Construction Drawings for Meridian Rd./Bent Grass Meadows Dr. Intersection Improvements

Engineering Review
07/17/2020 9:22:23 AM
dsdrice
JeffRice@elpasoco.com
(719) 520-7877
EPC Planning & Community
Development Department

**TRAFFIC CONTROL
 SIGNAL PLANS**
Bent Grass Meadows Dr./Meridian Rd.

SHT NO. : 1
 OF 6

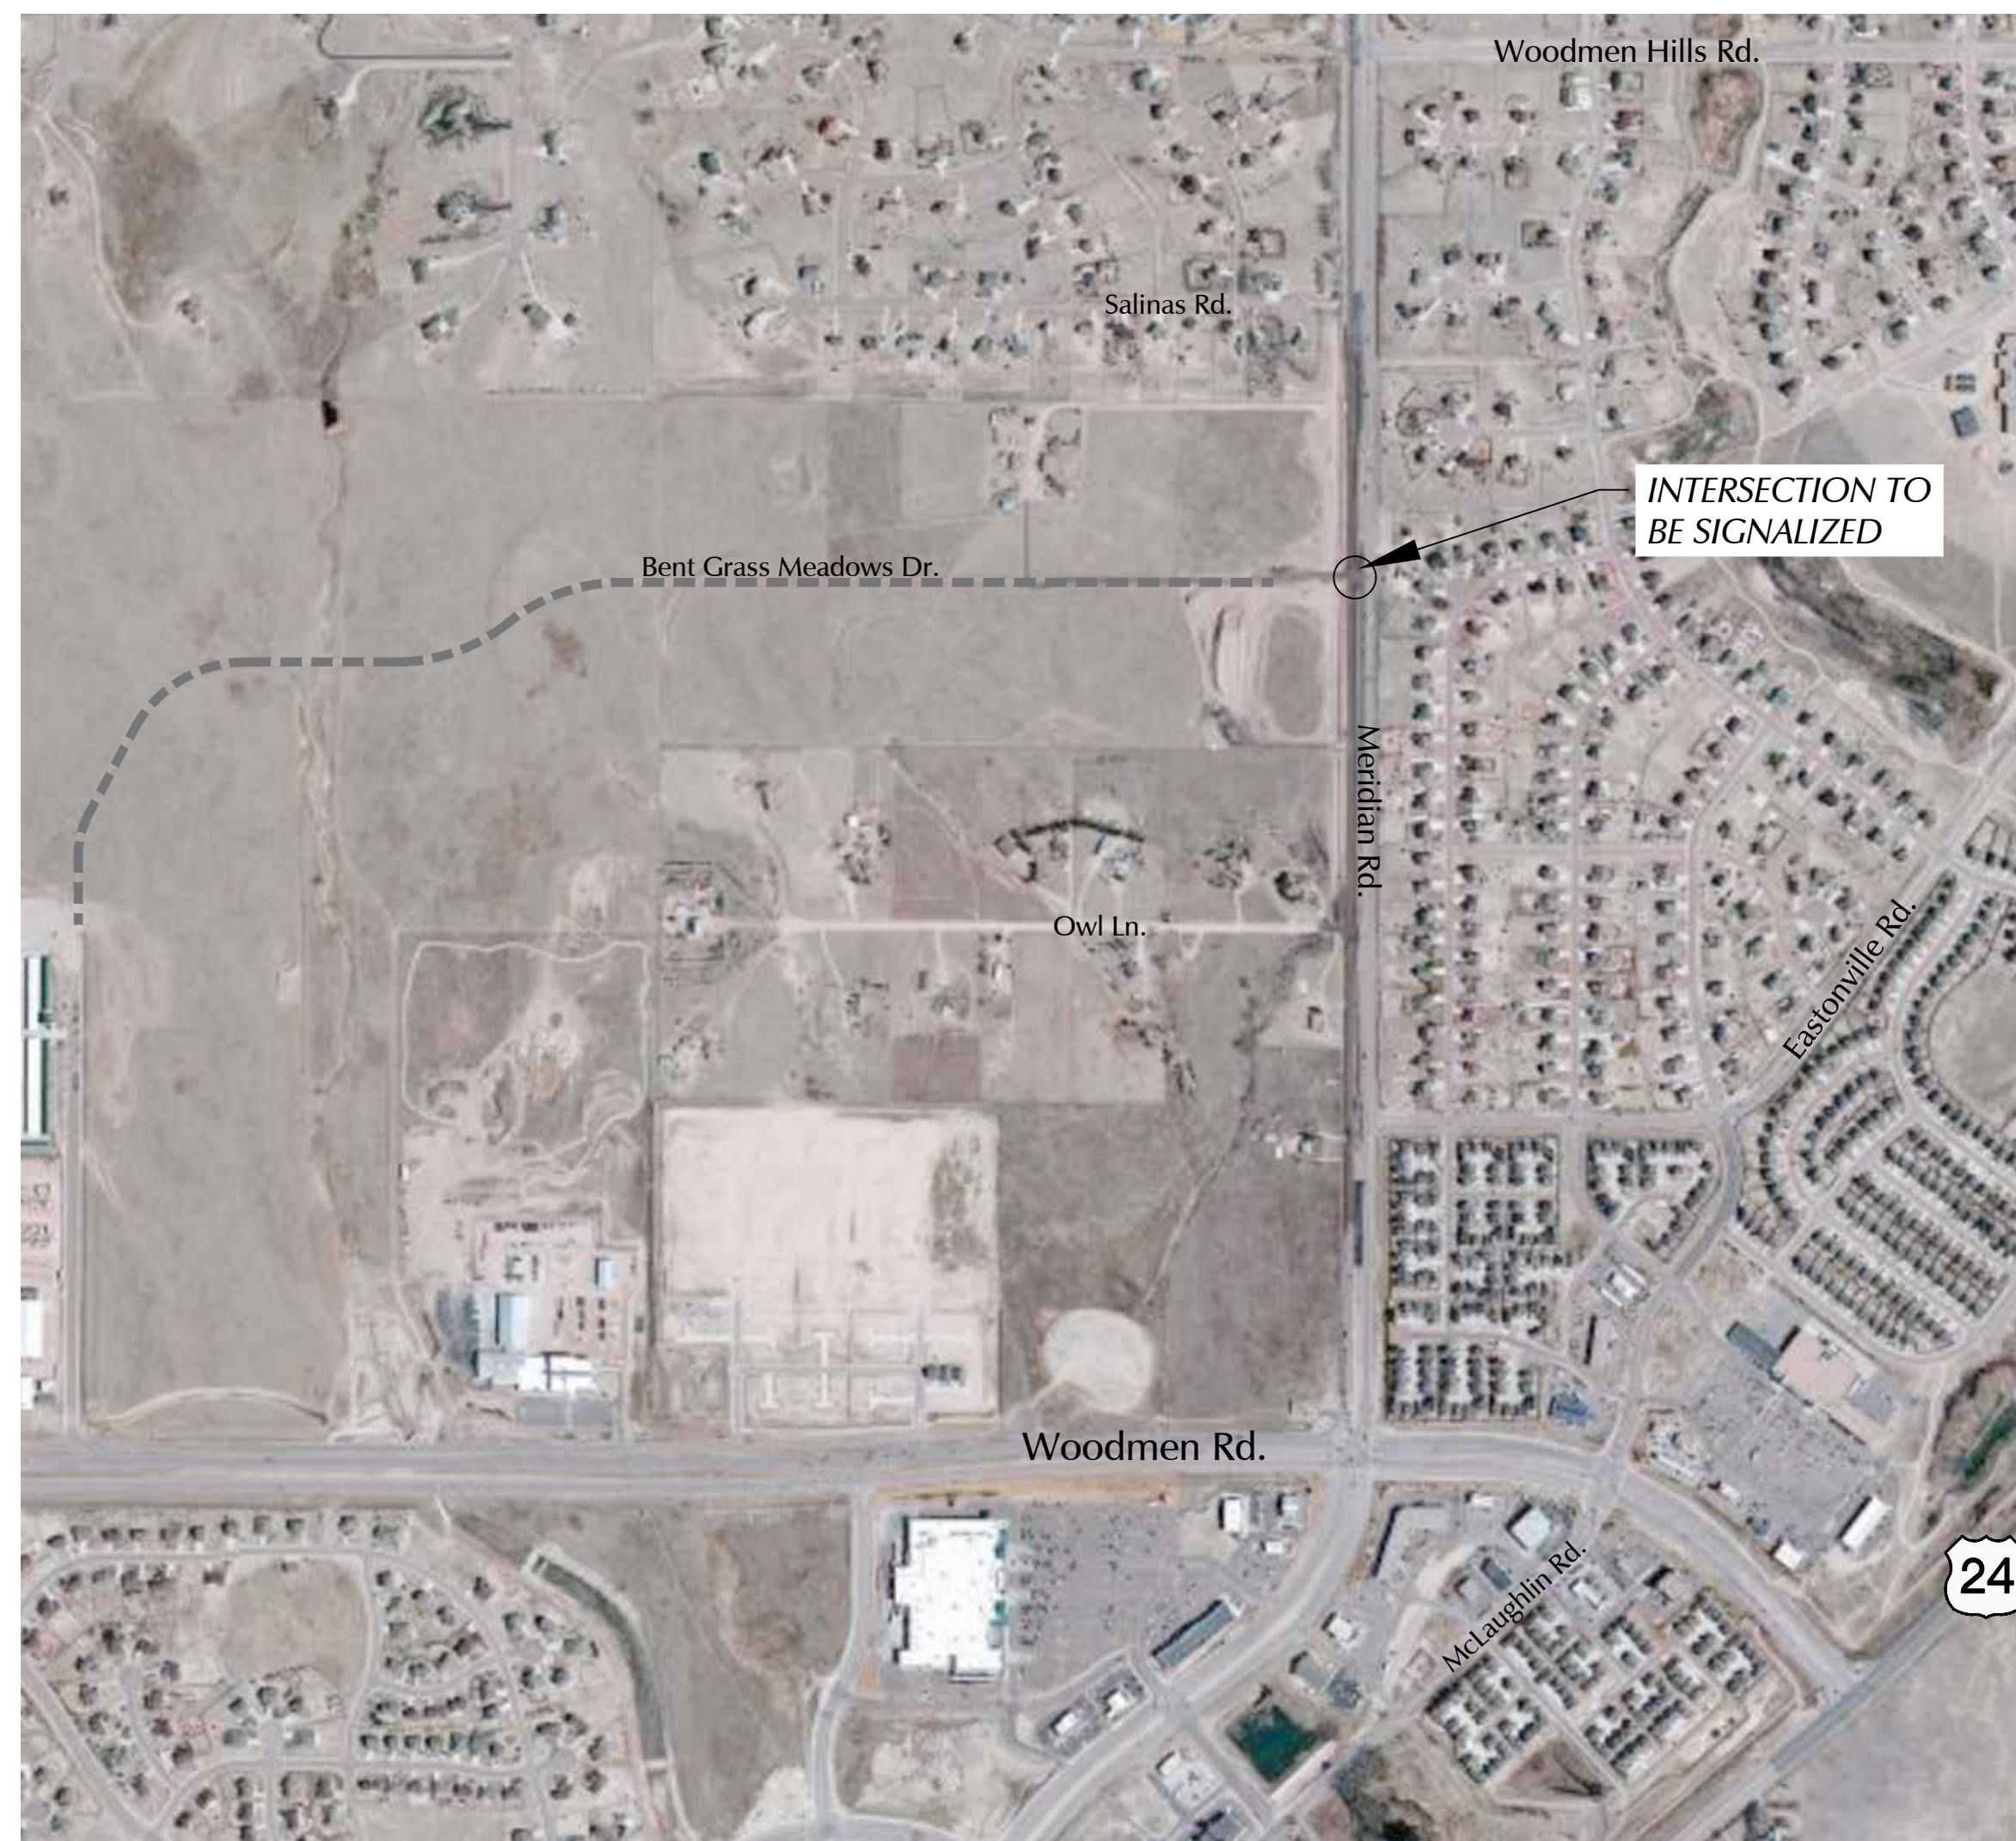
Should this be Challenger Communities, LLC or is the district providing financial assurances and agreements to ensure completion?

CITY OF COLORADO SPRINGS TRAFFIC SIGNAL FOUNDATION SPECIFICATIONS

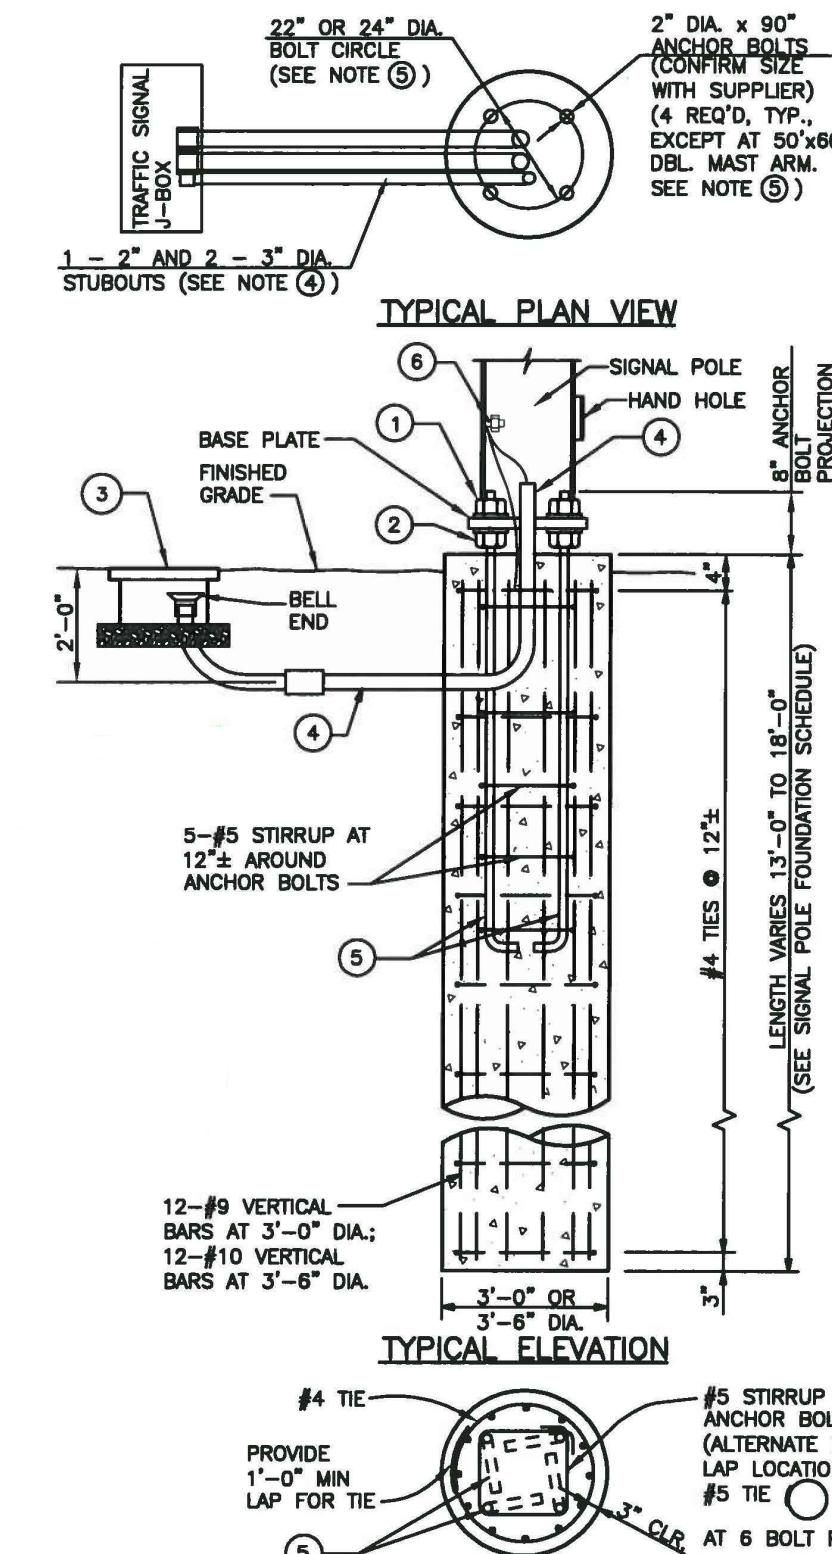
Verify no conflicts with EPC notes / CDOT specs.

SHT NO. 5
OF 6

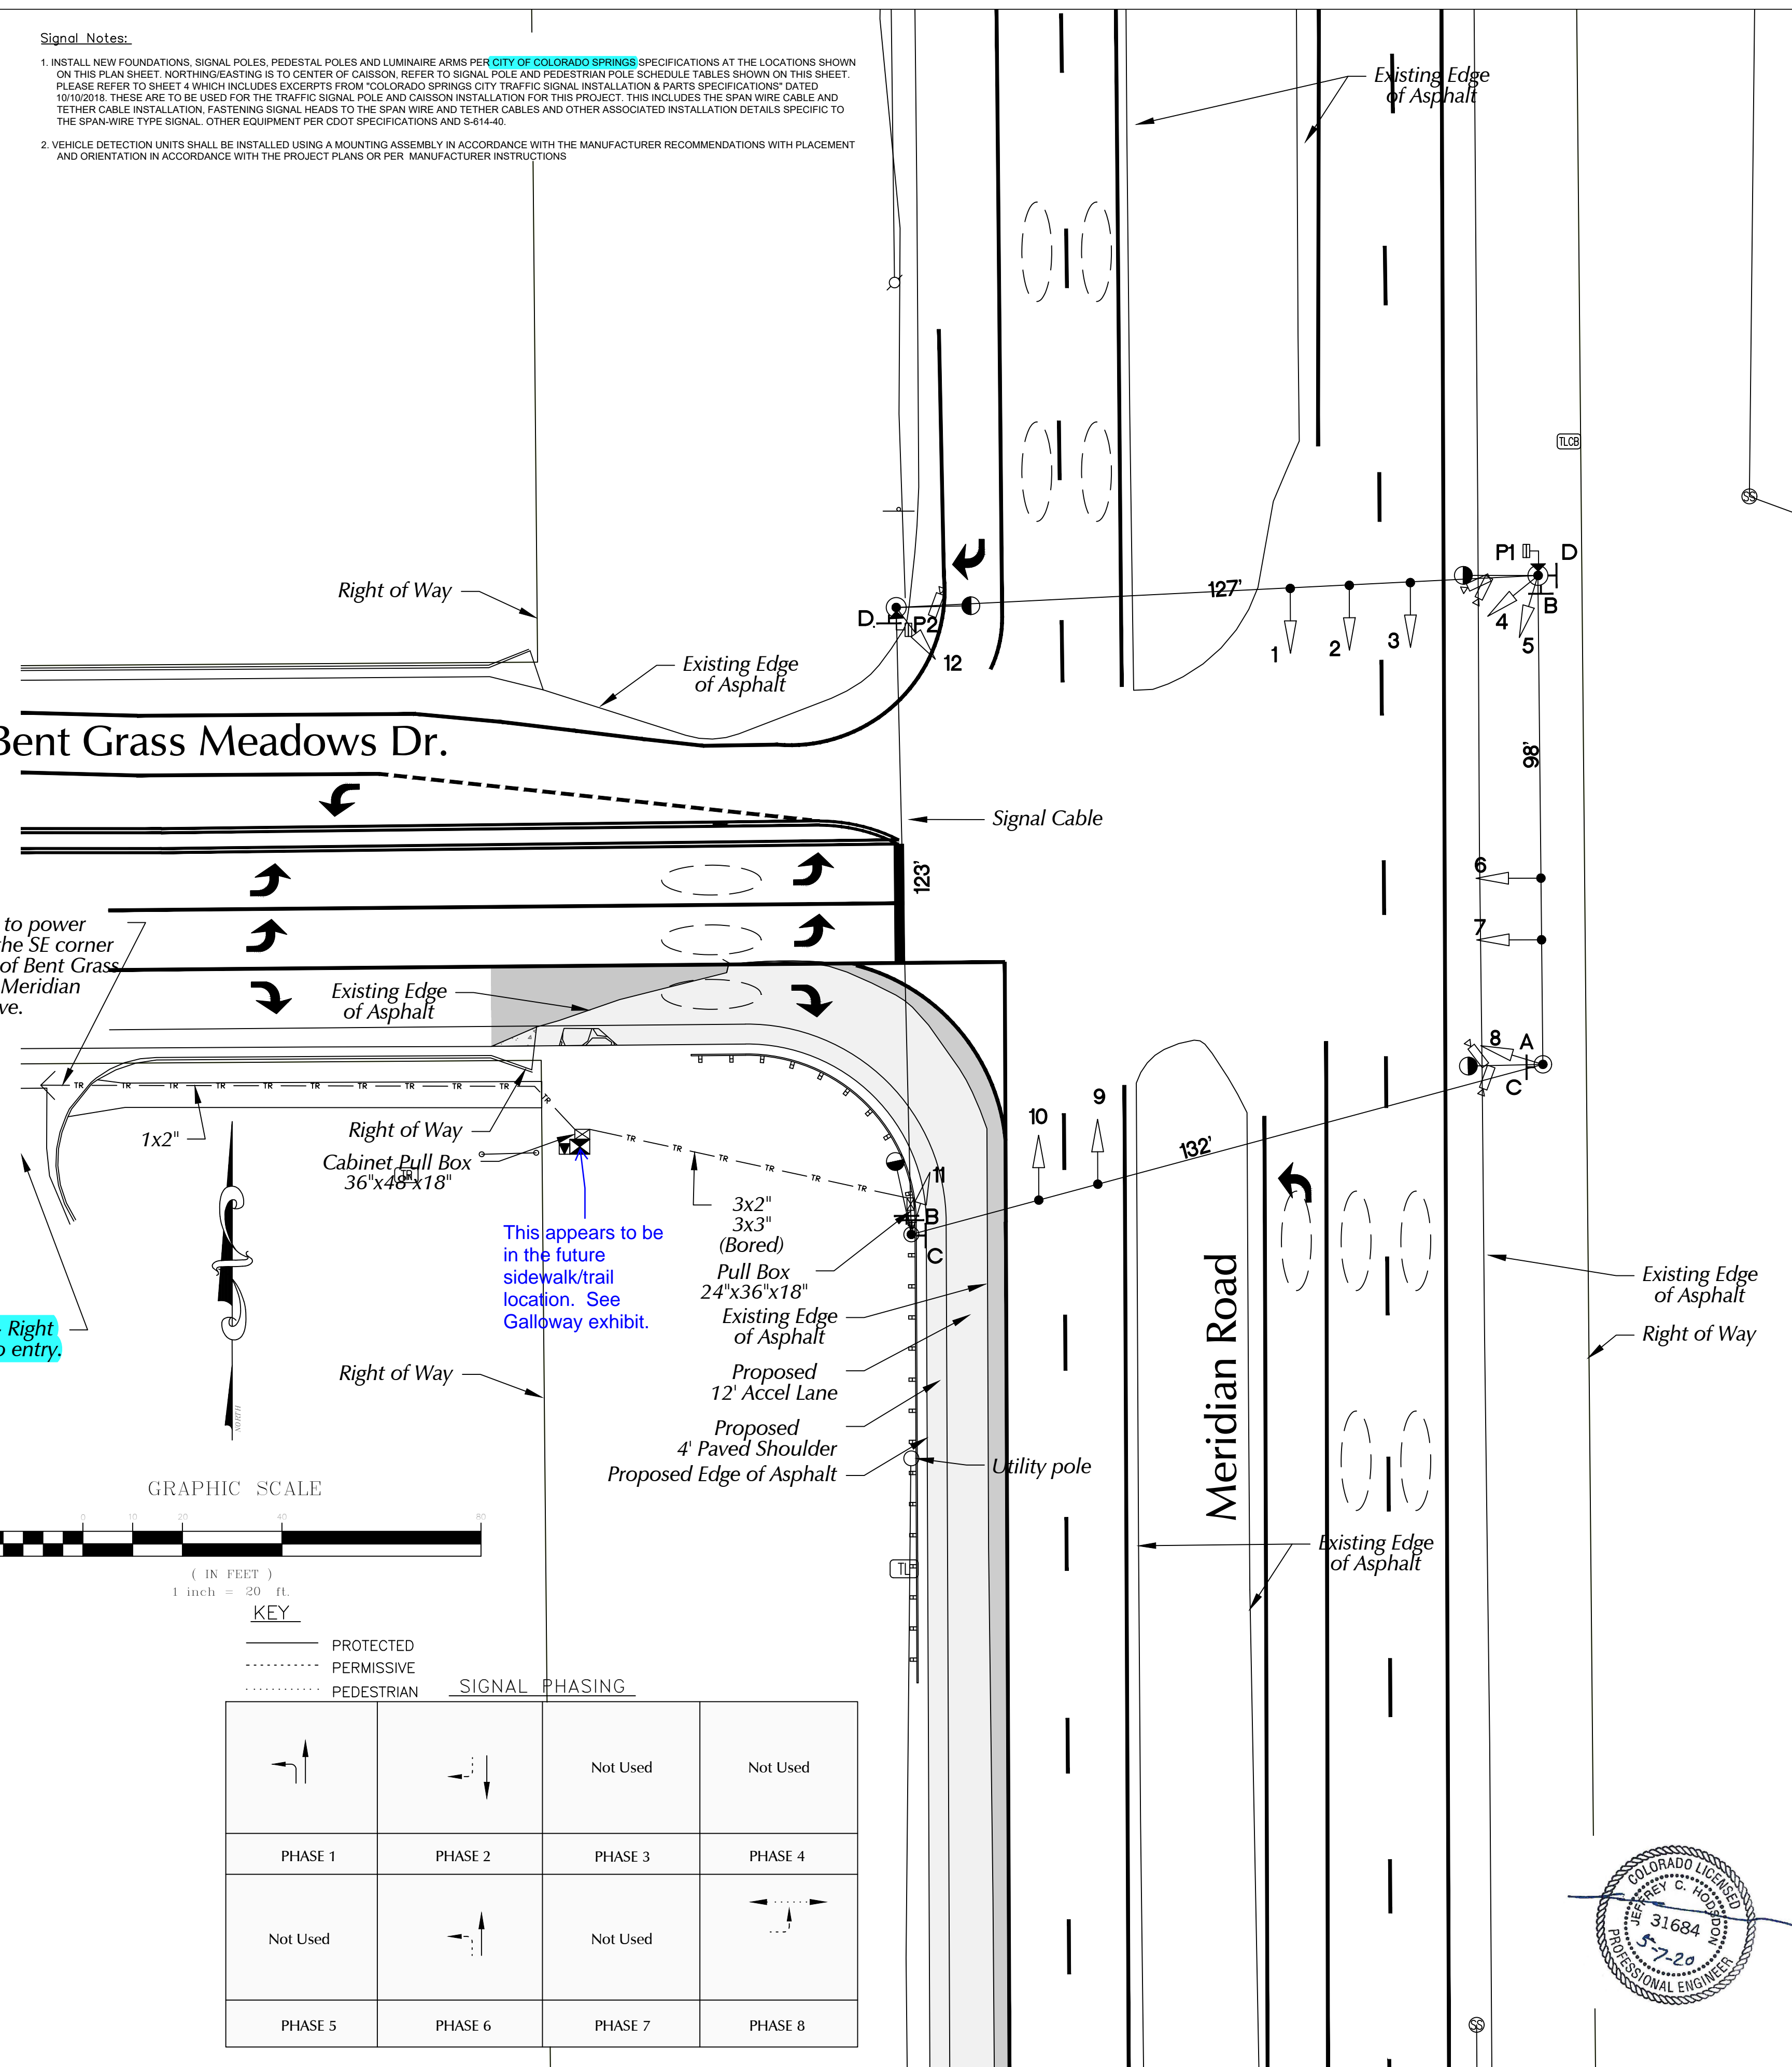
Same as gloss black?

Sign details to be included with shop drawing submittals

Are these needed? (Any crossings provided?)
Staff will check with DPW also.

Extend conduit to power source located at the SE corner of the intersection of Bent Grass Meadows and Meridian Park Drive.

This appears to be in the future sidewalk/trail location. See Galloway exhibit.
